# JP Research review of JASIC & BAST Flex-PLI Injury Reduction Estimate

GTR09 PH2 Informal Working Group

March 18<sup>th</sup> to 20<sup>th</sup>, 2013

**Figure 1.** Percentage of Serious Lower Limb Injuries\* that are Tibia Fractures

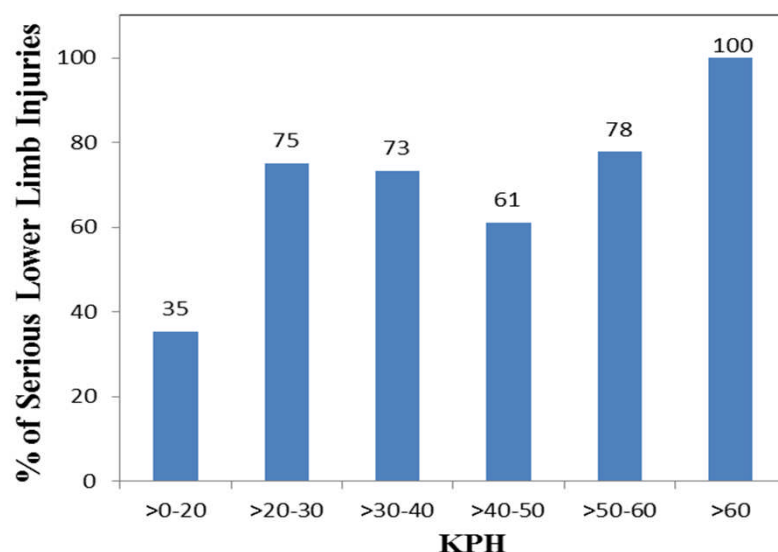
- JASIC used a factor of 66% to convert “Serious Lower Extremity Injuries” to “serious Tibia Injuries” (GTR9-5-14) . JPR’s analysis showed that this approach results is an over estimate of Tibia injuries.
  - JPR found 121 serious lower extremity injuries in the PCDC (MAIS2+, excluding fatalities), 75 (62%) were Tibia fractures and the % varies significantly across the impact speed, see figure-1 below.

- Because of the small sample size of PCDS it’s difficult to estimate an average conversion factor similar to the JASIC study. However, the Injury distribution versus speed, figure-1, can be used to check the potential tibia injury numbers.
- If the PCDS speed category distribution is used with the data in GTR-5-14 the serious tibia injuries would be 30% lower than the JASIC estimate.

Source: GTR9-8-14, page 5

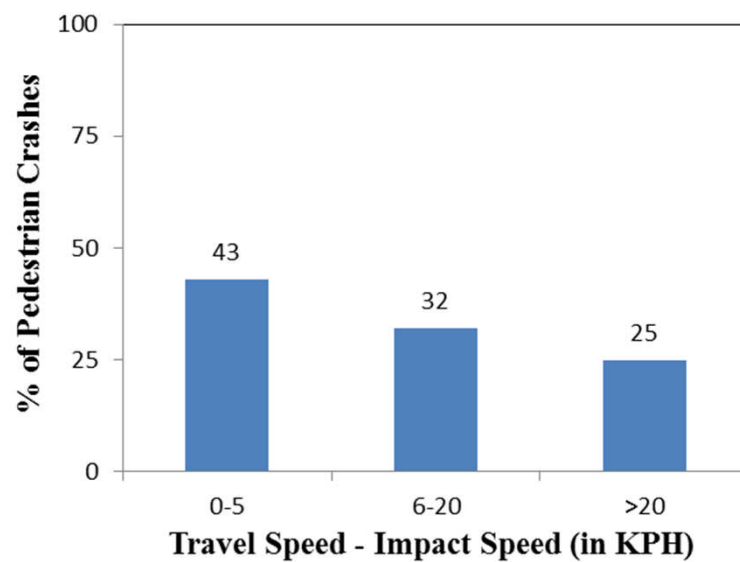
PCDS Speed categories result in 30% lower tibia injury estimate  
Average conversion factor is ~47%

Figure 3. MAIS Injury Distribution for all Pedestrians

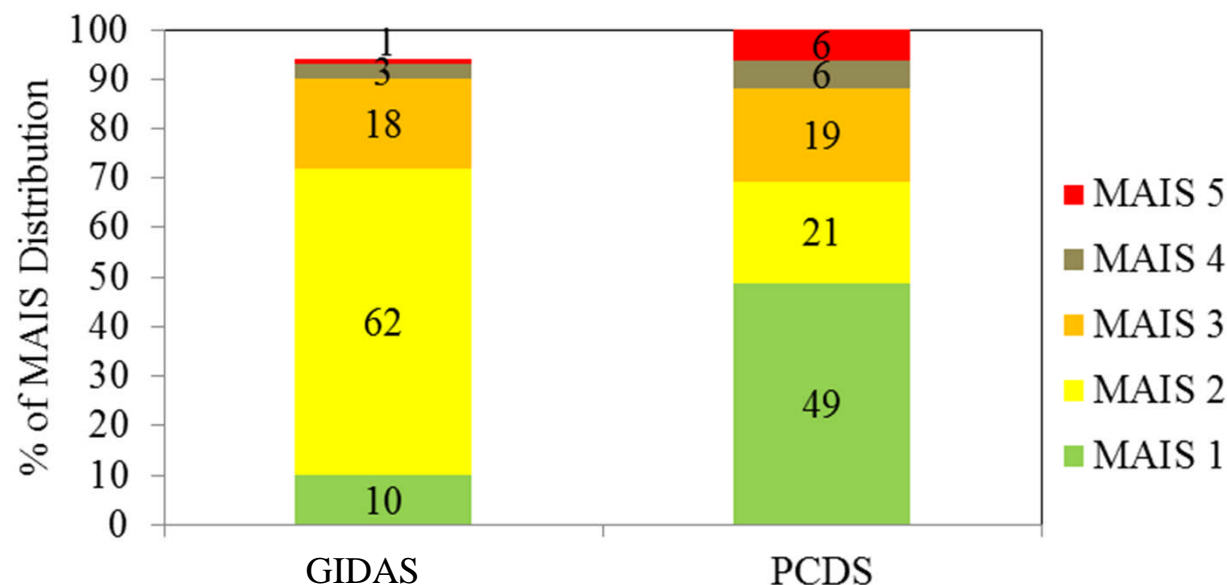
BASt tried to estimate the potential pedestrian injury reduction by taking the Pedestrian injury pattern in GIDAS database and shifting the risk curves by one AIS level.

- This would not be valid for the US case because there are significant differences in the distribution of Injuries.
- The study assumes a relationship between the MAIS level in GIDAS and injury classification by police reports, this is not the case in the US.

- The injury distributions of pedestrians involved in crashes are markedly different between Germany and US, ex. GIDAS has 62% of the pedestrian injuries as MAIS-2 versus only 21% in the US. Therefore, estimating injury reduction by shifting MAIS-2 to MAIS-1 would result in a significant overestimate of injury reduction in the US.
